Proposed Changes for SPI-4

00-246r2

Paul Aloisi TI

The driver/receiver electrical changes proposed for SPI-4

Figure 49 Paced Timing diagram and the paragraph under the figure TBDs replaced a table expect for the free running clock which is 100 mV.

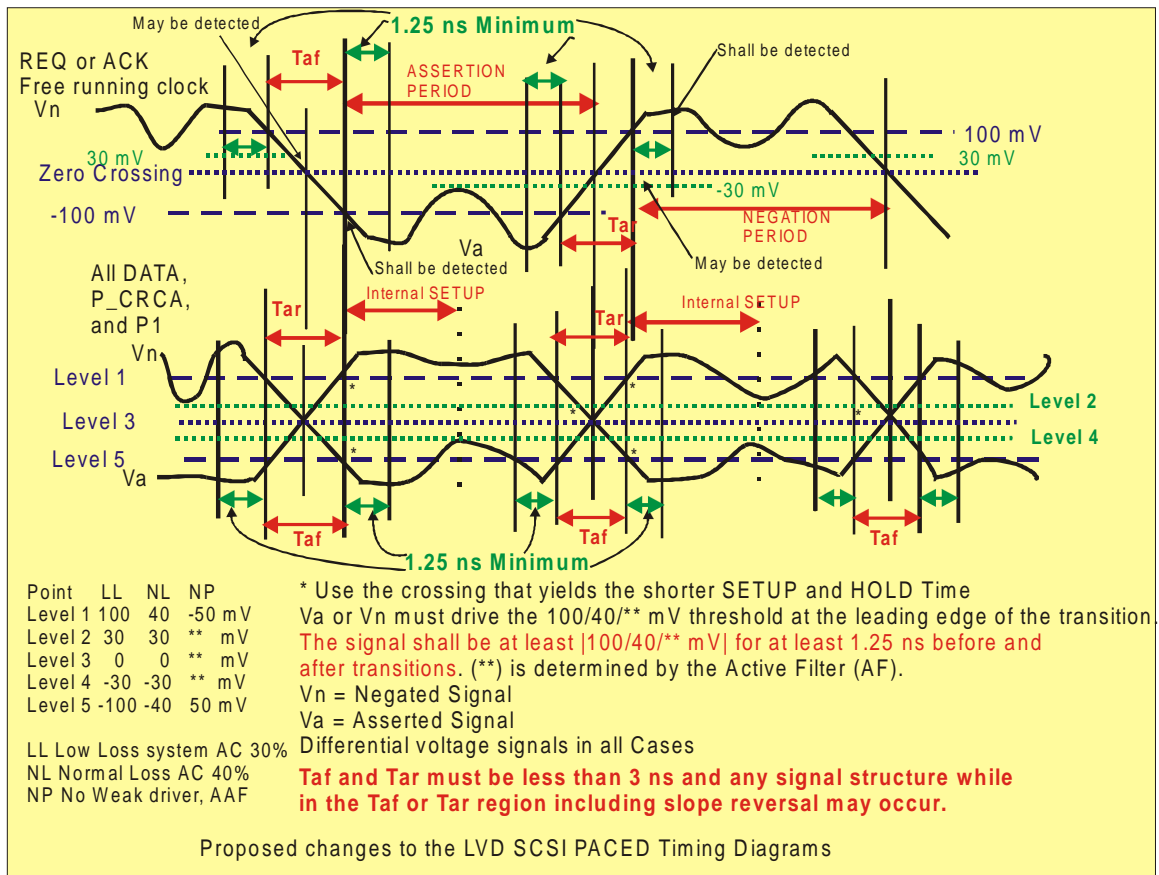
Low Loss (LL)

The signal shall transition for LL (low loss systems) from -100 to +100 mV or +100 to -100 mV in 0 to 3 ns, the waveform between -100 and +100 mV is not otherwise specified. The absolute value of the signals shall remain above the 100 mV level for 1,25 ns at each end of the transition. The absolute value of the signals shall not drop below 30 mV except during the transitions (see 7.3.2).

Normal Loss (NL)

The Free running clock shall transition for NL (normal loss systems) from -100 to +100 mV or +100 to -100 mV in 0 to 3 ns, the waveform between -100 and +100 mV is not otherwise specified. The other signals, the first transition from the multiple bit level shall transition -100 to +40 mV or +100 mV to -40 mV, if there is an immediate transition the +40 mV to -100 mV or -40 mV to +100 mV. The absolute value of the signals shall remain above the 100 mV multiple bits or 40 mV for a single bit level for 1,25 ns at each end of the transition. The absolute value of the signals shall not drop below 30 mV except during the transitions (see 7.3.2).

Weak driver off / AAF Adaptive Active Filter (NP)

The Free running clock shall transition for NP (no weak driver systems) from -100 to +100 mV or +100 to -100 mV in 0 to 3 ns, the waveform between -100 and +100 mV is not otherwise specified. The other signals, the first transition from a multiple bit level shall transition at least 150 mV and shall be a minimum 50 mV from the zero crossing, example -200 mV level shall transition to -50 mV for a valid transition.

The absolute value of the multiple bit signals shall remain above the 100 mV for 1,25 ns at each end of the transition. The absolute value of the signals shall not drop below 30 mV except during the transitions (see 7.3.2).

Figure 51 and 52 Receiver Mask paced data transfer needs to be different for the 3 camps, there should be 3 new masks

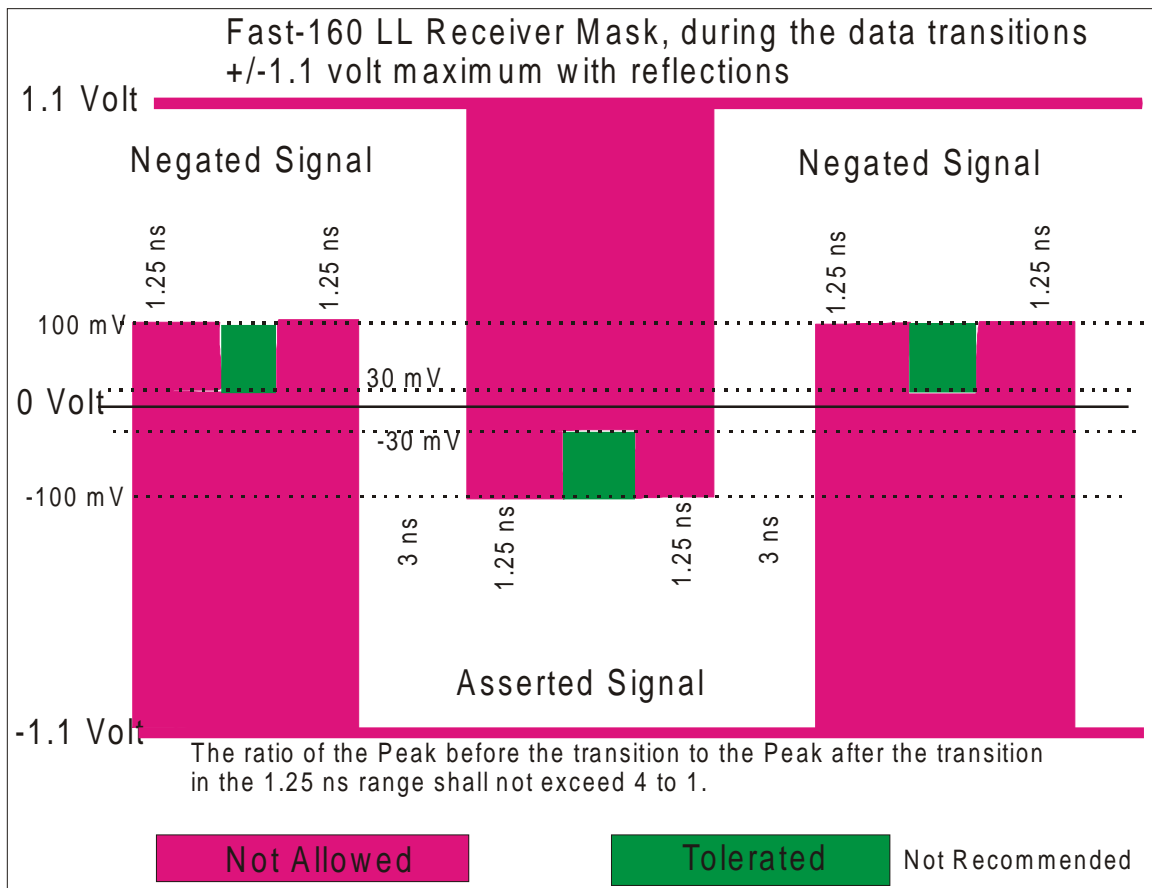
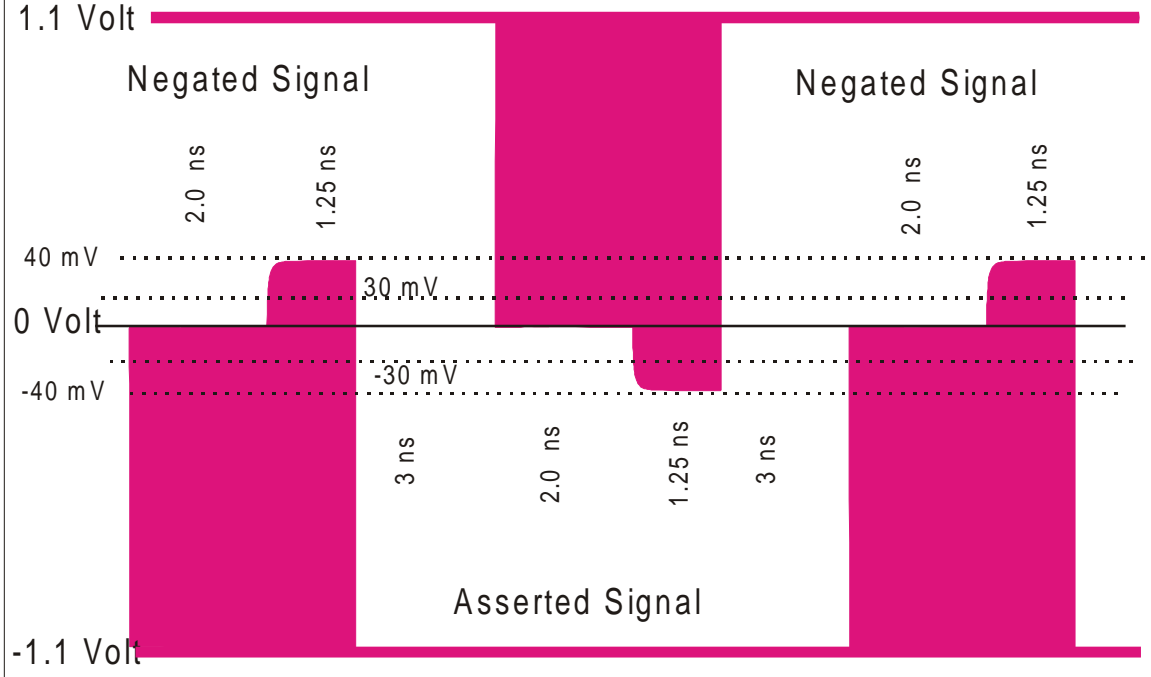
Fast-160 Receiver Mask NL, during the data transitions
 +/-1.1 volt maximum with reflections

The ratio of the Peak before the transition to the Peak at the end of the next bit time in the 1.25 ns range.
